Traffic Impact Assessment;

26 Elizabeth Street, Liverpool

For Binah Group
13 January 2020

2. Council & RMS Comments

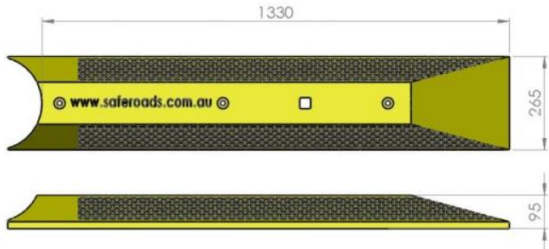
Item 3:	
<i>Vehicular access from proposed ROW to Bigge Street should be left-in/left-out being in close proximity to traffic signals. A central median may be required which means traffic assessment and modelling need to be updated.</i>	<p>ptc. recommends the installation of a separation kerb to restrict any right-turn movements in and out of the proposed ROW and Bigge Street.</p> <p>A separation kerb will mitigate the need for any road realignment or widening, whilst achieving the objective of enforcing a left-in, left-out arrangement.</p> <p>A concept drawing has been prepared incorporating the provision of a separation kerb spanning for a length of approximately 20m within the Bigge Street carriageway. Refer to Drawing No. CP-001 in Attachment 4.</p> <p>Based on the technical specifications of a typical separation kerb supplied by Saferoads, a standard separation kerb has a width of 265mm which can be accommodated within the existing double-solid dividing line marking (RMS BB-line) which has a total width of 300mm. See Figure 2.1 and Figure 2.2 for reference.</p>  <p>Figure 2.1 - Typical Separation Kerb by Saferoads</p>

Comments	ptc. Response				
	<table><tr><td>BB</td><td>1. Replaces separation line if restricted sight distance for both directions or 2. Approach to median island or 3. Approaches to a pedestrian crossing</td><td></td><td>White</td></tr></table> <p>Figure 2.2 - Standard RMS BB Line Marking Detail</p>	BB	1. Replaces separation line if restricted sight distance for both directions or 2. Approach to median island or 3. Approaches to a pedestrian crossing		White
BB	1. Replaces separation line if restricted sight distance for both directions or 2. Approach to median island or 3. Approaches to a pedestrian crossing		White		
Item 4:					
<i>SIDRA electronic files should be submitted.</i>	To be submitted separately.				
Item 5:					
<i>Network capacity at the Bigge St/Elizabeth St and George St/Elizabeth St intersections are already constrained and requires additional uplift will further reduce capacity and level of service. RMS requires further information regarding vehicle and pedestrian cycle phasing arrangements and intersection lane layouts used in the SIDRA traffic modelling.</i>	SIDRA model to be submitted separately.				
Item 6:					
<i>RMS advises that set cycle times at Bigge St are 120 seconds and the cycle times within the Liverpool CBD at 100 seconds. Clarification is requested why a 60 second ‘network practical’ cycle time was used in the traffic modelling.</i>	The SIDRA model has been updated to include a set cycle time of 120 seconds for intersections on Bigge Street and 100 seconds for intersections within Liverpool CBD.
